**Inspection and modification of oil hose attachment.**

Ing. Vladimír Pekár, Head of Design Organisation

All SHARK types and models.

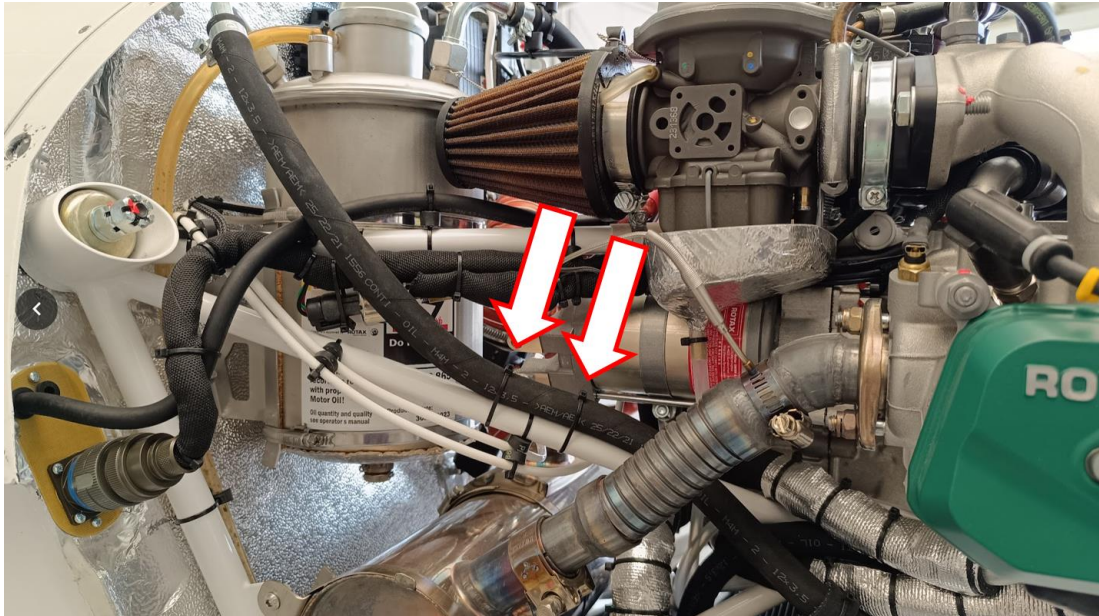
The purpose of this service bulletin is to address a potential safety issue concerning the current attachment of the oil hose (see figure below) using two plastic zip ties. The deterioration of these zip ties can result in failure, allowing the oil hose to come into contact with the exhaust tube. This could potentially cause an oil leak, posing a safety hazard.

The oil hose is currently secured with two plastic zip ties. If the zip ties fail, the unsecured oil hose could shift and contact the nearby exhaust tube, potentially leading to a rupture or leak due to high temperatures.

To mitigate this risk, the hose will be repositioned so it leads behind the middle engine mount tube.

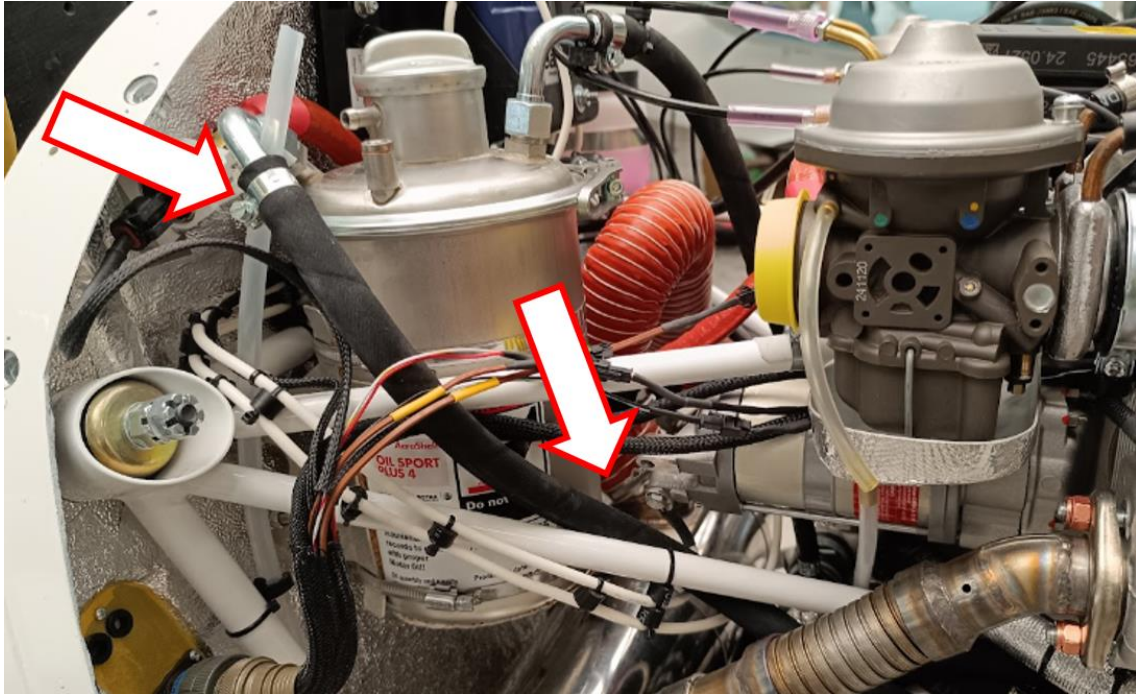
- Inspect the oil hose attachment in the engine compartment, verify the condition of the plastic zip ties.
- If any zip ties are found to be deteriorating, frayed, or broken, replace them with new plastic zip ties as a temporary fix.
- Ensure the oil hose is not in contact with the exhaust tube.
- If contact is observed, do not operate the aircraft until the issue is resolved.

- Remove the existing plastic zip ties.
- Disconnect the hose from the oil tank by loosening the screw on the hose clamp and pulling off the metal tube.
- Seal the hose with a suitable plug or cap to prevent oil from spilling.
- Route the hose behind the middle engine mount tube as shown in the next figure:

- Secure the oil hose using 2 zip ties to the middle engine mount tube, ensuring that the zip ties do not compress the hose.
- Verify that the oil hose is securely fastened and positioned away from the exhaust tube or any sharp edges.
